Access Compliance Report

Public Rights-of-Way

(Pedestrian Signals)

Intersection ID: N/A	Main Street:	Cross Street: N/A	Location: N/A
ADA ID: FAFDAF0F7110	Signal Type: One Push Button-Non APS	Overall Compliance: No	Severity Score: BTN 1: N/A BTN 2: N/A No BTN: N/A
Codes/Mitigation Info/Possible Solution		Field Measurements/Component Compliance

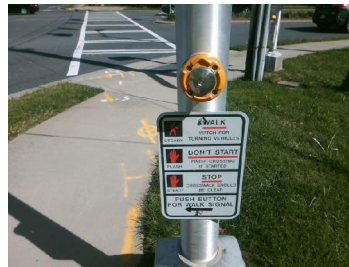
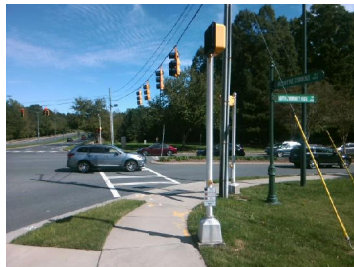
Surveyor Notes: N/A

PROW/ADA: TMUTCD 4e.08

Yes	B 1 Clear Xing Direction?	ClearlyMarked	N/A	B 2 Clear Xing Direction?	N/A
	B 1 Crossing Direction	To NW		B 2 Crossing Direction	N/A
Yes	B 1 DistanceTo XWalk (in)	0.0	N/A	B 2 DistanceTo XWalk (in)	N/A
No	B 1 DistanceTo Curb (in)	160.0	N/A	B 2 DistanceTo Curb (in)	N/A
Yes	B 1 Diameter (in)	2.0	N/A	B 2 Diameter (in)	N/A

Possible Solutions: Replace Signal Push Button With APS Button on New Post. Remove & Relocate Sign.
